INSTRUCTION TO SERVICE

ITS: 6348

SECTION:	405-005 Artic Joint
WRITTEN BY:	Dwayne Peters
SUBJECT:	Hubner bellow interference

Figure 2: Trim the end legs, both sides.

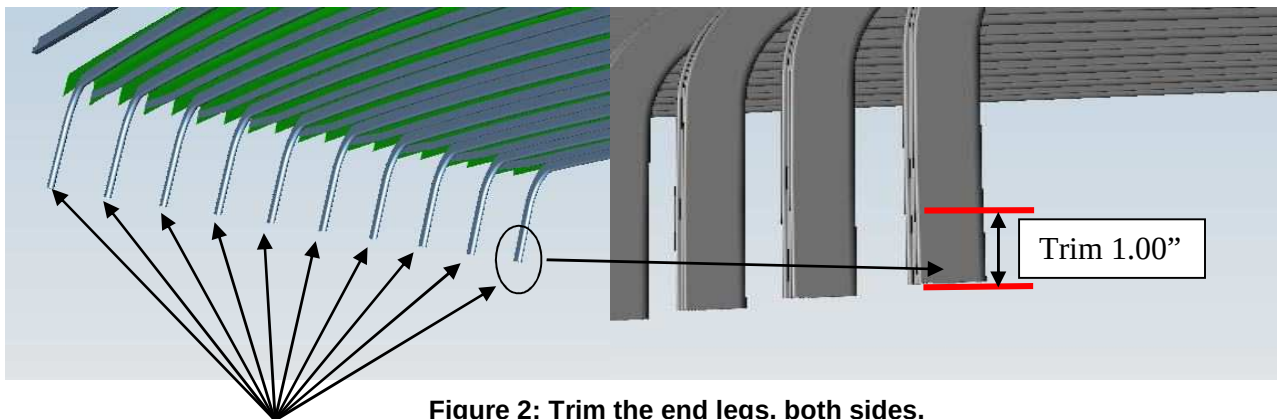
- b. Remove and discard the screws from the end caps that attach the legs of the false ceiling bellow to the outer bellows.
 - c. Remove the false ceiling bellow from the vehicle.
2. Trim 1.00" off all the end legs as shown in figure 2. Remove burrs.

Figure 3: Trim the 5 studs

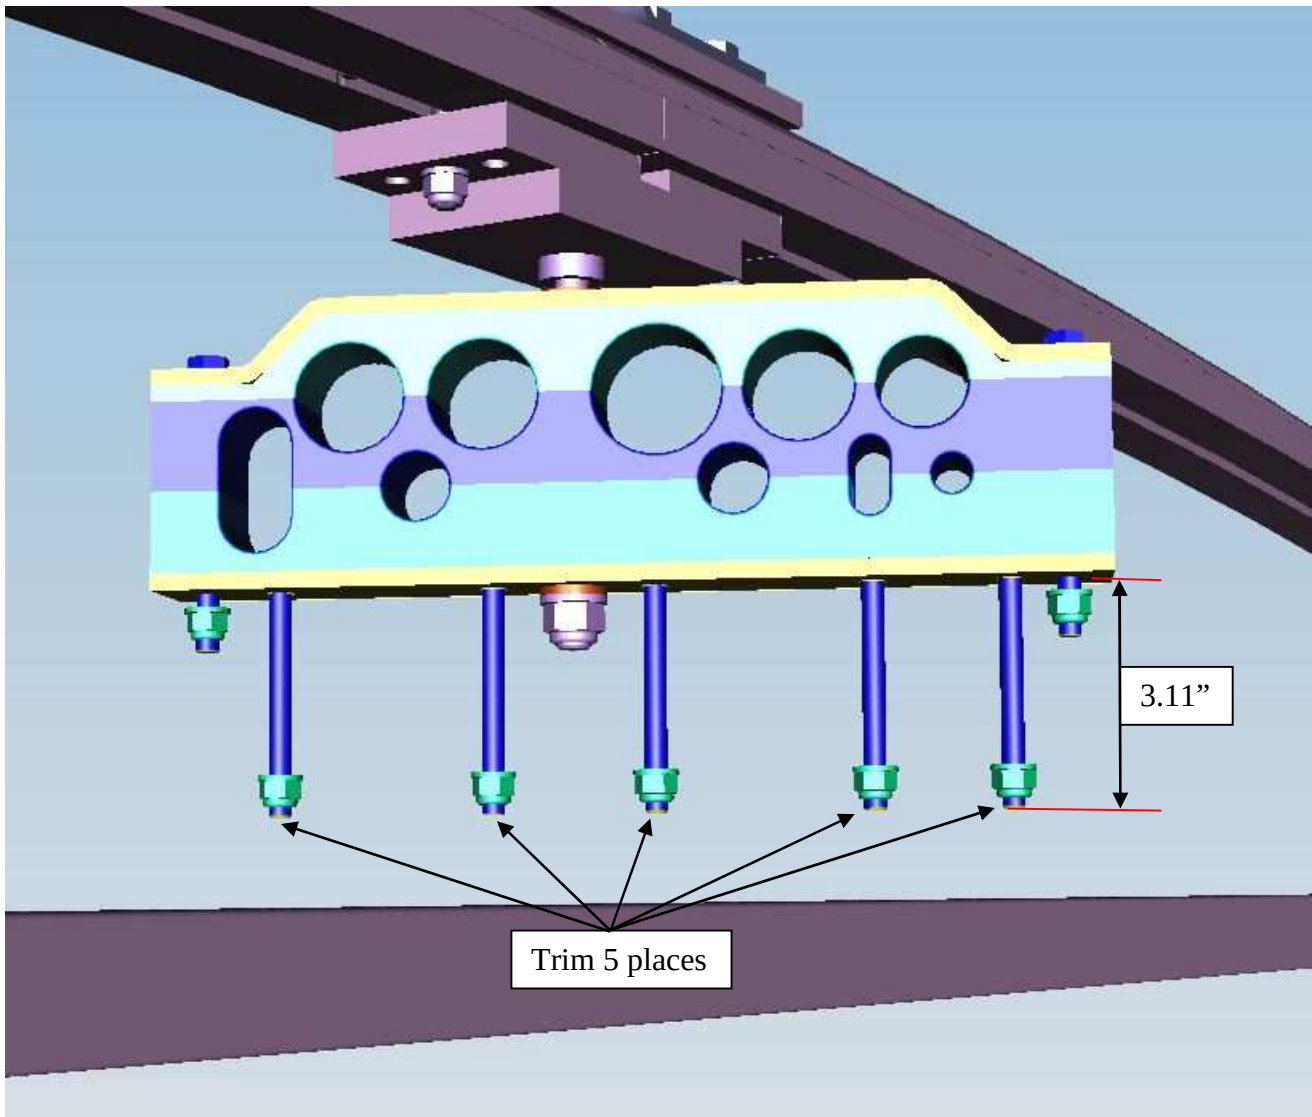
3. Trim the 5 studs on the spider clamp to the dimension shown in figure 3. Ensure there's two threads remaining outside of the lock nut face. Remove any sharp burrs.

Figure 4: Loosen the screws, both sides

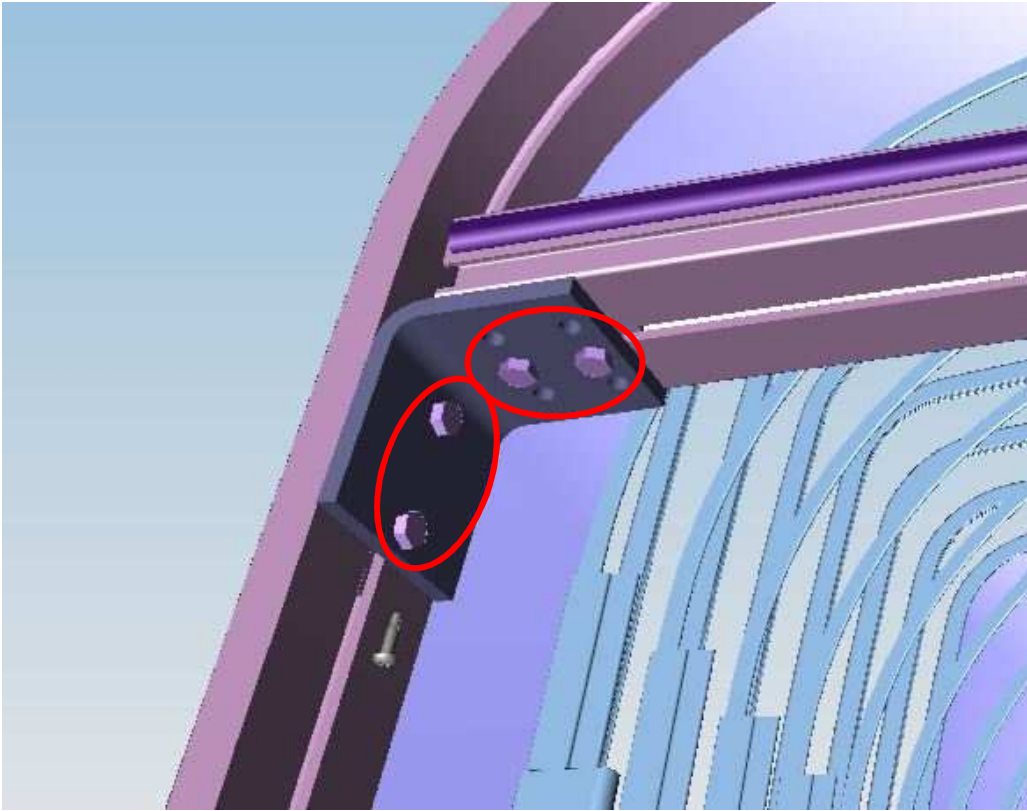
5. Measure the space between the hoop profile and false ceiling strut in the center as shown in figure 5. Lower the false ceiling strut to 10.50" by loosening the 8 retaining screws ensuring the strut is level when complete by measuring to the floor in two places while maintaining the 10.50" dimension. Figure 4 and 5. Torque the screws to 177 in-lbs.

Figure 6: Check to ensure gaps are equal.

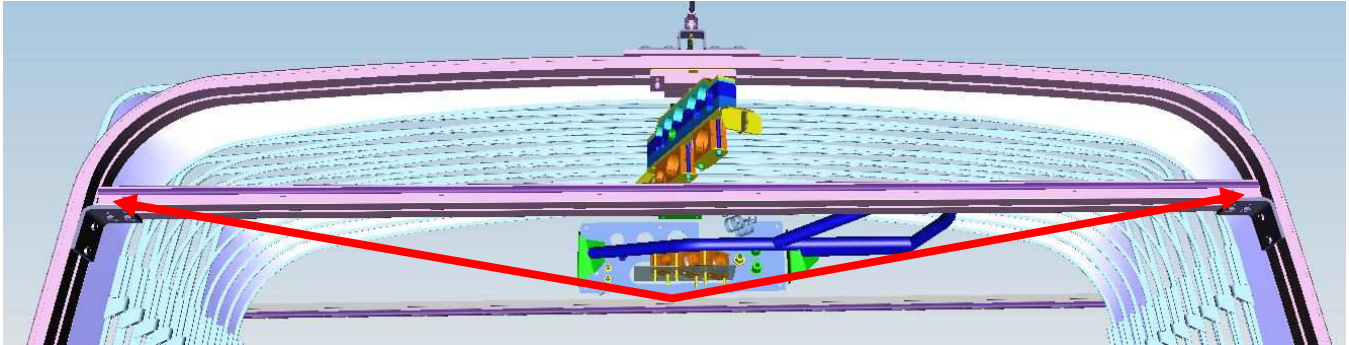
6. Check to ensure that you have an equal gap on each side of the false ceiling strut after adjustment. Figure 6.

Figure 7: Cutaway of stanchion and stanchion retaining cup

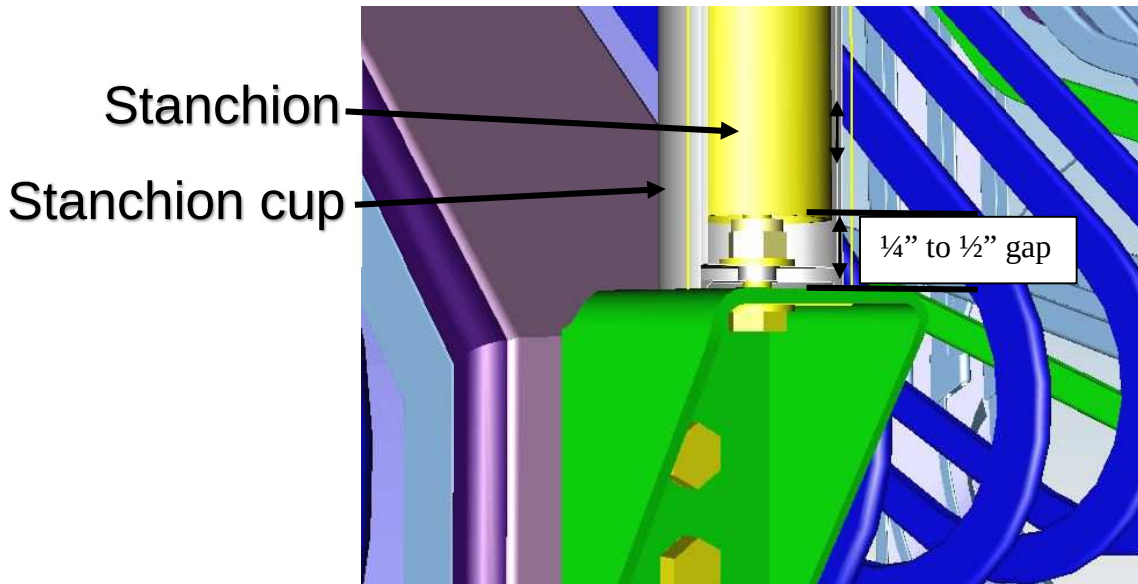
7. Trim the bottom of the stanchion (if so equipped) so when installed there's a $\frac{1}{4}$ " to $\frac{1}{2}$ " gap from the bottom of the retaining cup as shown in figure 7. Remove sharp burrs.
